Determination 2024/069

Regarding the compliance of building work with Building Code Clause E1 Surface water

189 Tanners Point Road, Tanners Point, Bay of Plenty

Figure 1: Property setting out and new driveway

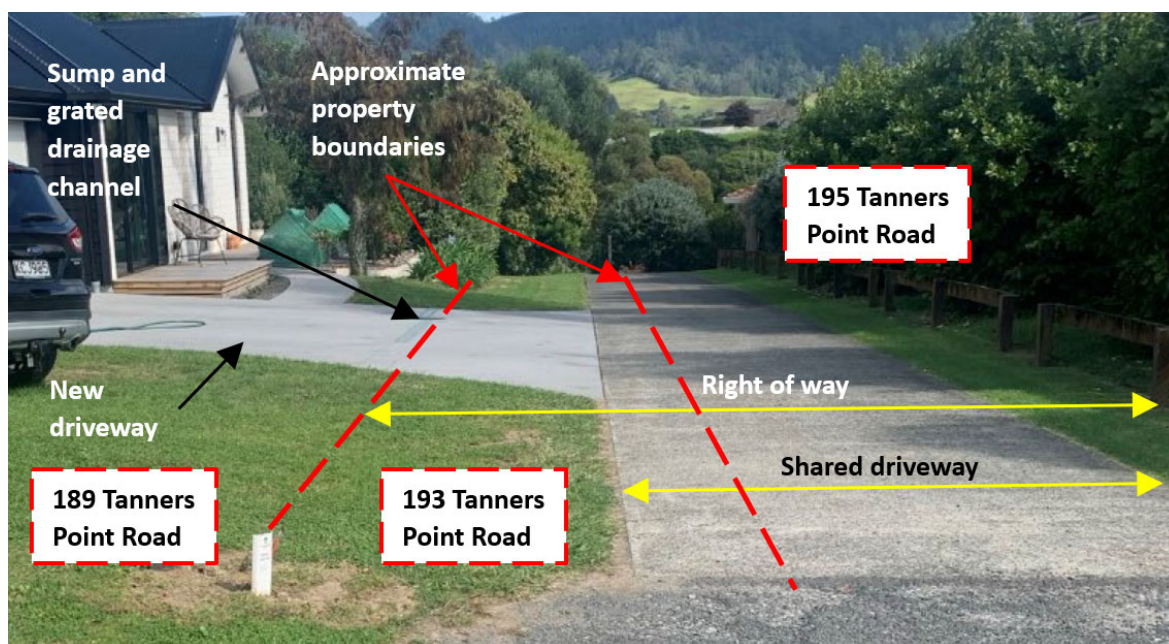
- 2.6. Set into the new driveway is a proprietary 130mm wide x 130mm deep grated drainage channel and type-1 surface water sump.⁹ See Figure 3, marked by a blue line.

2.14. On 13 November 2023, an additional 1.6m grated drainage channel was installed by the owners to the west side of the new driveway and connected to the existing sump, bringing the total length of the channel to 4.9m. The as-built grated drainage channel does not extend the full width of the new driveway, but based on photographs appears to extend approximately three-quarters of the width.

- 4.6. Because the channel drain does not extend the full width of the new concrete driveway, some of the surface water will reach the section of driveway constructed over the adjacent property (193 Tanners Point), and a portion of this is likely to reach the shared driveway/right of way. However, I consider the amount this contributes to water reaching 195 is minimal and does not meet the threshold of 'nuisance' for the purposes of E1.31.

- 4.7. I have considered the size and capacity of the as-built grated drainage channel, and in conjunction with data provided by the manufacturer,¹⁷ I am satisfied it is adequate for the catchment area (ie 32m²) of the south part of the new driveway. I also note the authority also considered the size of the sump installed and concluded it complied with Acceptable Solution E1/AS1 (refer to paragraph 3.6.1).
- 4.8. In conclusion, I am satisfied the as-built grated drainage channel and sump are adequate in terms of the collection and disposal of surface water received from the dwelling, and so the building work complies with clause E1.3.1.

- 5.1. In accordance with section 188 of the Building Act 2004, I determine the building work in respect of the surface water collected and disposed of via the channel drain and sump, complies with clause E1.3.1.
